Determination 2025/027

The refusal to grant an amendment to a building consent to include external wall claddings terminating in channel drains

Block 18, 241 Park Estate Road, Karaka, Auckland

Figure 2. Block 18 site diagram showing locations of proposed channel drains.

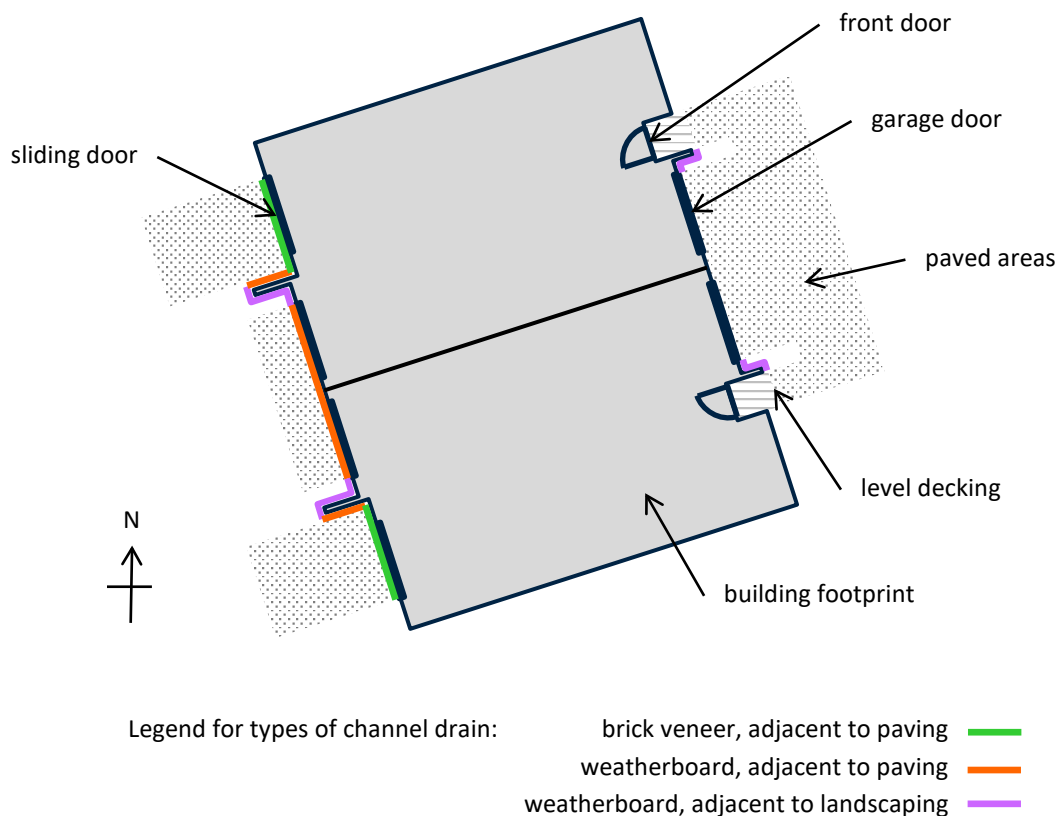
- 2.8. The proposed locations and configurations of the external wall cladding systems and channel drains are as shown in Figure 2. In the remaining areas of the external cladding, the ground levels fall away from the building, and do not include channel drains at the base of the wall.

Figure 4. Detail for the proposed channel drain adjacent to weatherboard cladding

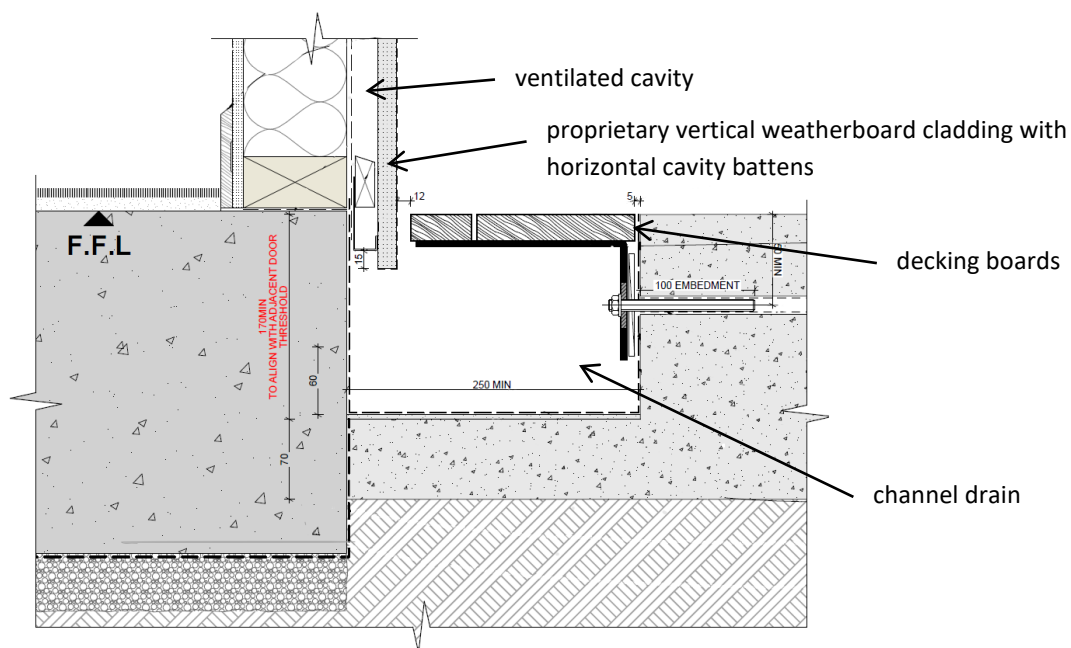
- 2.10.3. The weatherboard cladding is shown to extend into the channel drain, below the level of the decking by approximately 30mm, with the base of the cavity behind the weatherboard cladding terminating within the channel drain.

- 2.10.4. The maximum height of the weatherboard cladding is approximately 3.9 meters. The top of the weatherboard cladding is covered by eaves in some areas and is exposed in other areas.

- 2.10.5. Where the top of the weatherboard cladding is protected by eaves, the top of the cavity is not vented. Where the top of the weatherboard cladding is not protected by eaves, the top of the cavity includes a ventilation gap for airflow.

- 4.29. One disputed detail involves the proposed use of a proprietary fibre cement vertical weatherboard cladding system, incorporating a cavity, the base of which terminates with a channel drain.

4.40. Therefore, in my view, the owner’s comparison to paragraph 7.3.2.1 and Figure 17B of E2/AS1 and the appraisal does not support or establish the Building Code compliance of the proposed proprietary fibre cement vertical weatherboard cladding system with cavity, terminating within the channel drain.

4.41. As neither the compliance report nor the appraisal sufficiently addresses the impacts or risks associated with the proposed weatherboard cladding system terminating within a channel drain altering/impacting the intended functioning of the drained cavity set out in E2/AS1, I find that the plans and specifications do not demonstrate that the cladding system would achieve compliance with the performance requirements of E2.3.3, or E2.3.5 as an alternative solution.

Figure 3. Detail for the proposed channel drain adjacent to brick veneer cladding.⁵

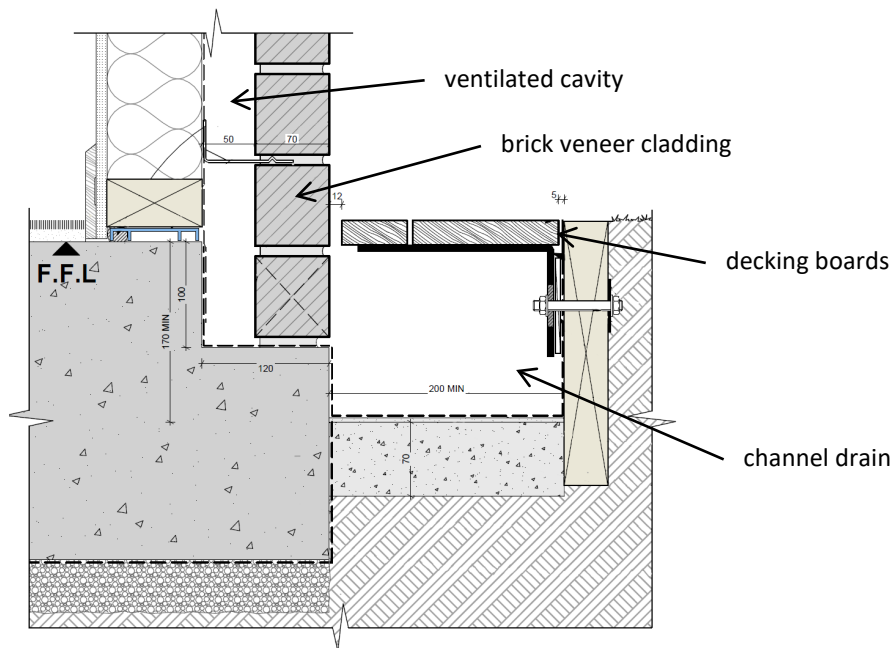
- 2.11.3. The brick veneer cladding is shown to extend into the channel drain, below the level of the decking by 100mm, with the weep holes of the brick veneer cladding from the cavity also being located below the top of the channel drain and terminating within the channel drain. The maximum height of the brick veneer cladding is approximately 3.9 metres.

- 2.11.4. The base of the cavity behind the brick veneer cladding sits 70mm above the base of the channel drain. The top of the cavity is ventilated and covered by eaves approximately 1.5 metres deep.

4.45. The other disputed detail involves brick veneer cladding incorporating a cavity, the base of which terminates within a channel drain (see paragraph 2.11).

- 4.48. The owner did not provide evidence specific to the brick veneer cladding system which addressed these differences from E2/AS1 or associated risks with altering the performance of the E2/AS1 drained cavity, such as the passage of moisture through the lower row of bricks and weep holes located within the channel drain. The plans and specifications therefore do not establish how compliance with the performance criteria of E2.3.3 and E2.3.5 would be achieved as an alternative solution.
